Access Compliance Report Public Rights-of-Way (Curb Ramps)

Main Street: CRANBROOK_DR Cross Street: KOOTENAY_DR Location: NW

ADA ID: RPAT211001103815 Ramp Type: Type 1 - Perpendicular Diagonal Initial Pass/Fail: Pass Overall Compliance: No Severity Score: 20

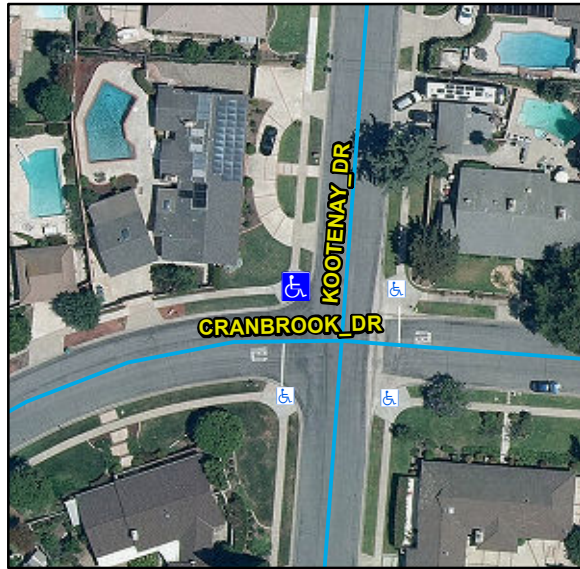
R304.2.2, R304.2.1, R304.2.2-Perp, R304.3.2-Para, R304.5.3, R305, STD 1115

Remove & Replace Curb Ramp With Two New Directional Ramps or Equivalent.
